TECHNICAL MEMO REVIEWING Final Initial Study/Mitigated Negative Declaration for the Meadow Way Bridge Replacement Project
Laurel Collins, May 29, 2020

At your request, I have reviewed technical documents and reports prepared for the Final Initial Study/Mitigated Negative Declaration ("MND") for the Meadow Way Bridge Replacement Project ("Project"). In addition, I have reviewed published landslide maps of the US Geological Survey, viewed available official online Geographic Information System (GIS) maps in the MarinMap Map Viewer and the San Francisco Estuary Institute EcoAtlas, and reviewed 2013 Report from the Department of Fish and Wildlife East Marin County San Francisco Bay Watersheds Stream Habitat Assessment of San Anselmo Creek.

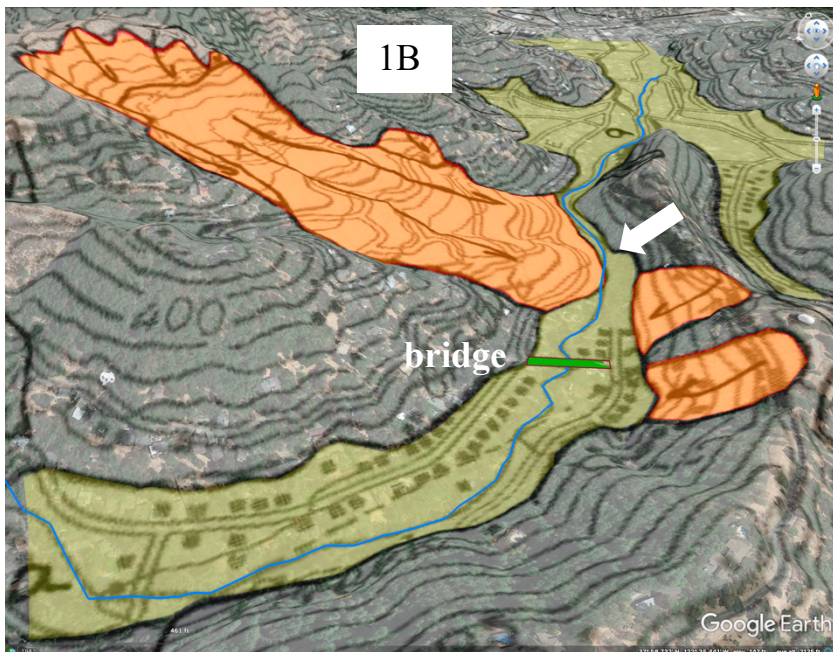
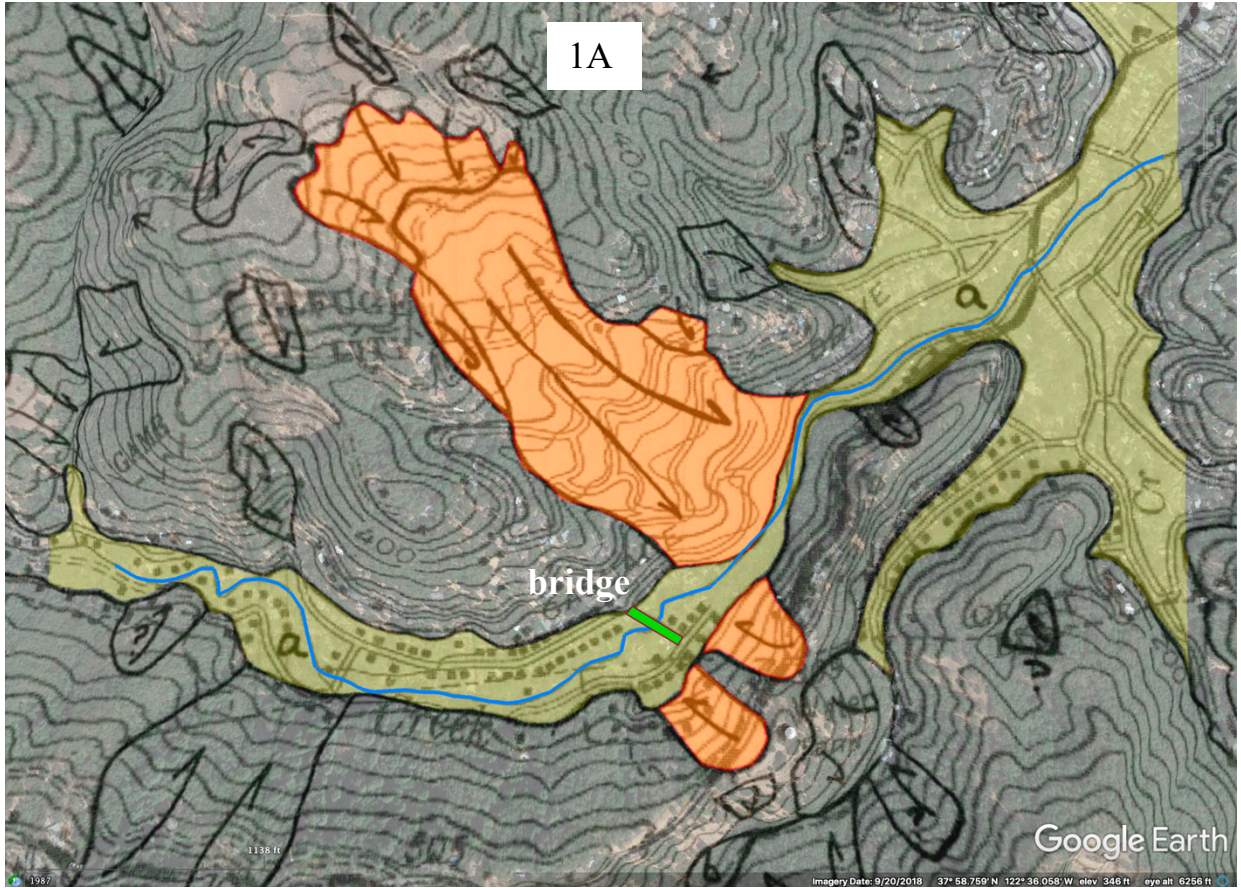
The MND does not appear to take into account the Project’s location near debris slide run-out pathways or the proximity of rotational and/or translational landslides along the adjacent hillsides that could put the Project site at risk from potential disruption from uphill slippage. There are off-site but very nearby landslides that could pose on-site impacts. The toes of the two landslides on the southern adjacent hillside have been mapped by Wentworth and Frizzell (USGS, Open File Map 75-281, sheet 11, 1975) (see Figures 1A and B). These slide features appear to be roughly 150 feet from the south side bridge abutment and extend over 400 feet in length from the edge of the alluvial valley to the ridgetop. The USGS map is online at the link below.

Further, a very large complex landslide, that extends over 3000 feet from ridge top to valley bottom is just downstream of the Project site (its western lateral scarp is about 300 linear feet downstream of the north bridge abutment on the north hillside and its movement at some time in the geologic past was sufficient sometime in the past to block the entire creek and cause backwater alluvial deposition that created the existing landscape of the Project site where now, a much wider alluvial valley exists upstream of the landslide pinch point. The MND provides no discussion or analysis about the existence of these slides or prospect of their future impacts during a large seismic event or extreme rainfall. If a prior large landslide created the alluvial valley that the bridge is sitting on, the MND’s characterization of this area as ‘flatland’ for purposes of landslide impact analysis is misleading and cannot be supported as free of potential geologic hazards.

The 1975 USGS landslide map indicates that the northeast abutment is not necessarily on alluvial sediments, yet the MND provides no information whether the abutment is on or near bedrock or the condition of the bedrock that exists. The MND does not explain whether the abutment is concordant with bedrock at depth on the other side or if there is evidence of faulting between the bridge abutments as could be possible due the presence of the fault that is mapped nearby, nor does it provide any information about the actual subsurface condition here and what is the known depth and condition of bedrock at the site. In my opinion without this information, the MND's impact assessment is inadequate as it fails to address the potential for impacts that could occur from severe seismic shaking from the large San Andreas and Hayward Fault systems as well as offset and sheared rock conditions from local mapped faults as well as landslides. Local faults and landslides can mechanically weaken the bedrock by shearing it, cracking it, and thereby weaken the strength of the bedrock to support structures. If either side of the bridge abutment is in different types of soil or bedrock structural design must be developed to suit the different conditions. Proximity of faults and landslides is a red flag to needing subsurface and off-site investigations to build safe structures that require piers for support.

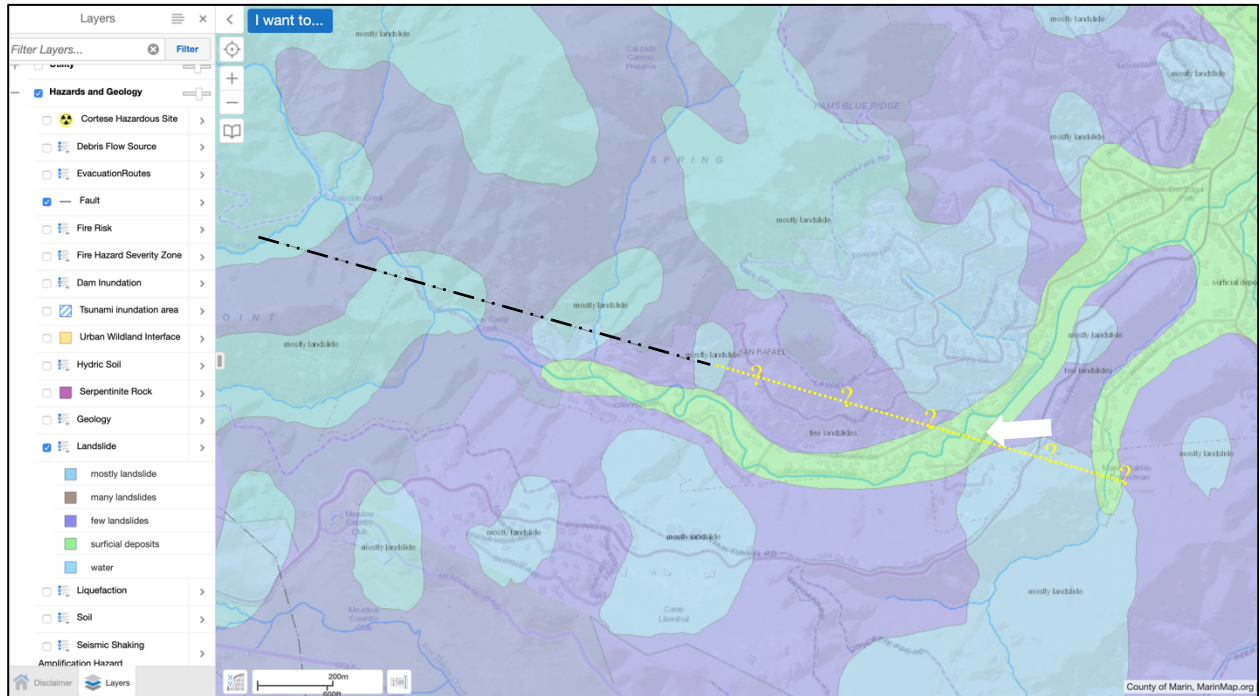
Interpretation of landslide conditions by Wentworth and Frizell is supported by recent landslide hazard classification shown online at the MarinMap Viewer, as shown in Figure 2. The current online map (as shown 5/2020) characterizes much of the watershed to be landslide prone. The area of large northern slide, as indicated by the earlier USGS mapping, is shown as mostly landslide and the extent of the toe is much closer to the Project site than previously indicated (about 150 linear feet as opposed to 300 feet. This suggests that recent landslide interpretation finds the extent of landslide hazard to be bigger yet there is no discussion of the reason for the differences in interpretation which could relate to possible recent landslide activity or more thorough investigations nearby.

Compounding this, the MND fails to describe accurately the seismic issues in the Project area, only concluding instead that the project site is not located within a State-designated Alquist-Priolo Earthquake fault rupture zone. In addition to the landslide hazards, the MarinMap Map Viewer (herein referred to as MarinMap) also shows a distinct northwest trending fault about 2200 feet to the northwest of the site. The MND fails to describe the fault or its southeastern projection into the footprint of the Project. This fact that they do not reference this source of information is even more bewildering given that they reference MarinMap as a source of GIS and environmental information. The importance of the fault should be evaluated relative to potential effects on the weakness of sheared and mechanically weakened bedrock at the site and for the potential for vertical or lateral offset during a large magnitude earthquake from the San Andreas Fault system. How the proposed structural design elements of the proposed bridge and piers may or may not be appropriate at this site must be evaluated given the unresolved presence of sheared bedrock due to either the projection of this fault or from
